ADDENDUM NO. 1

ANTIOCH COMMUNITY PARK

SYNTHETIC TURF FIELDS

ISSUED
January 9, 2013

EDGEBAND CONDITION III

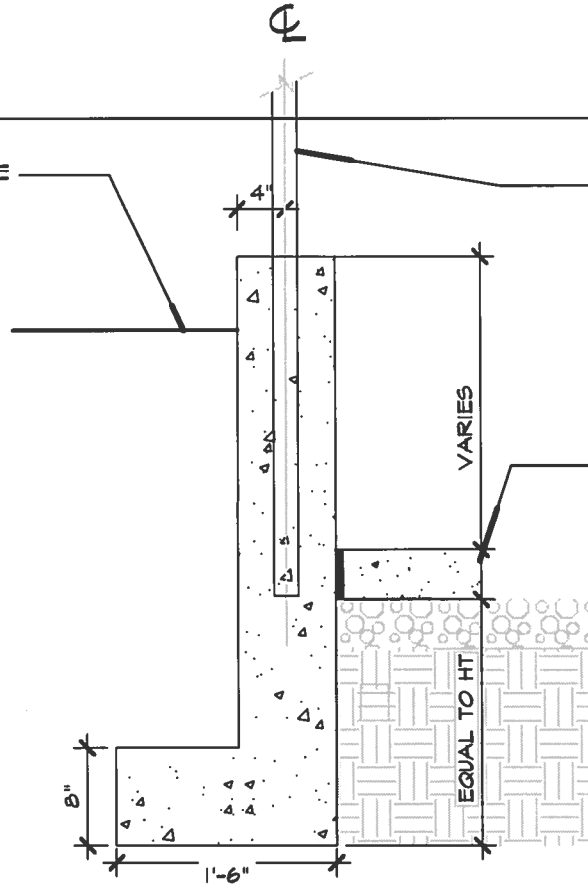
Item	Location in Contract Documents	Description
8.	Plan Sheet L-7 Planting Plan	Question: Plan Sheet L-7 Planting Plan note #1 states Contractor to provide 24" box trees qty. of 20. Are these trees to be provided only, or provided and installed? Please provide variety for bidding purposes. Answer: The variety shall be as follows: * Quantity 11- Fraxinus Oxycarpa "Raywoodii", (Raywood Ash) * Quantity 9- Pistacia Chinensis, guaranteed male, (Chinese Pistachio)
9.	Detail H on sheet D-2	Detail to be replaced with attached detail AD 1.1 Edgeband condition III
